Rebuild Project: **Vogt Recreation Center**
4131 Unruh Ave, Philadelphia, PA 19135

Re: Final Construction Approval from the Art Commission

ART COMMISSION FINAL REVIEW | MARCH 12, 2025

Shade Structure with Solid Roof | Monoslope by Poligon

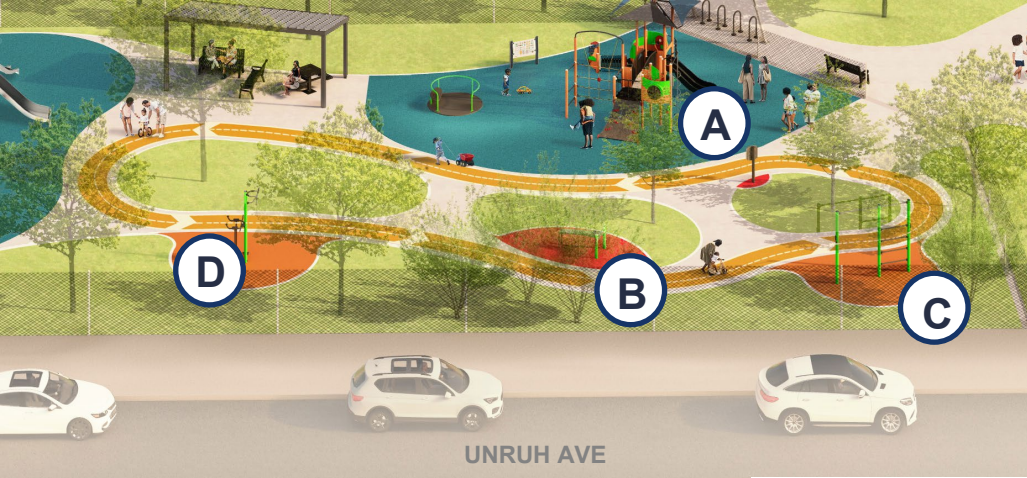
- The Commission would like to see a plan with the existing and new trees showing the caliper of those trees.
- Ensure that the shade structures maximize the amount they can cover, consider adding picnic benches under them
- Make sure standards are in place so that no materials contain harmful plastics.

The presentation has been updated to address the Commission's concerns. The updates include the existing tree plan and proposed tree plan including the species and caliper of each tree, the proposed slatted pergola has been changed to a shade structure with solid roof, and included are specifications ensuring the safety surface does not contain harmful plastics. Refinements have been made to both the building and playground to include specific equipment, colors and materials. The building design now also includes a seat wall at the front entrance to help define the space.
